AGENDA
Planning & Zoning Commission
Regular Meeting
San Luis Council Chambers
1090 E. Union Street
San Luis, AZ 85349
Tuesday, July 9, 2024
6:00 P.M.

REGULAR MEETING
PLANNING AND ZONING COMMISSION
SAN LUIS COUNCIL CHAMBERS
1090 E. UNION STREET
JUNE 11, 2024
6:00 p.m.

Comment Letter dated July 5, 2024

ORCHIDEA PARK TOWNHOMES SUBDIVISION PHASE 1

TYP. LOT BUILDING SETBACK LAYOUT

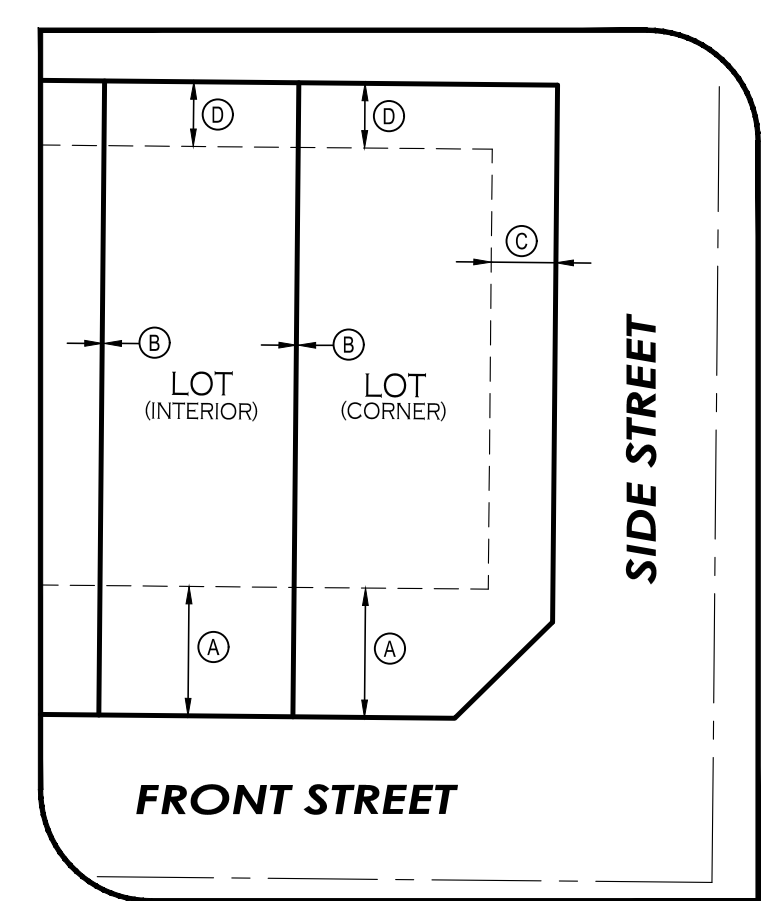
8. Legal description on plat and dedication should read: "A Subdivision of lot B of San Luis Port II Subdivision as recorded..."
9. On TYP. Lot Building Setback Layout show 10' side yard setback on visibility triangle.

24TH AVENUE C
3

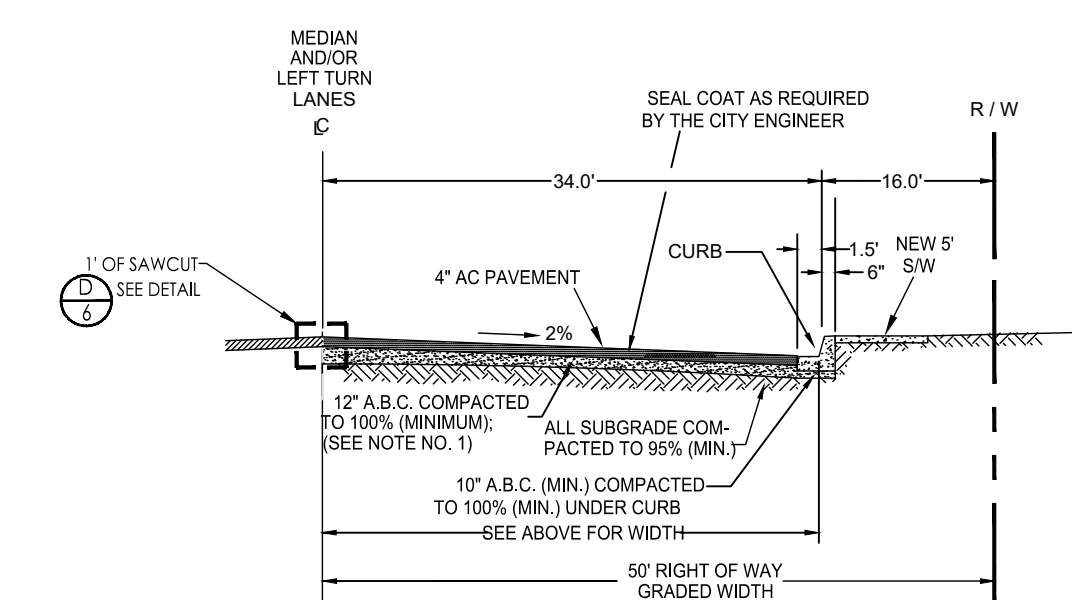
6. For 24th Avenue section to match northern developments with a centerline to curb dimensions of 26.0' and 5' sidewalk.
7. Reference detail to Keynote 7 accordingly.
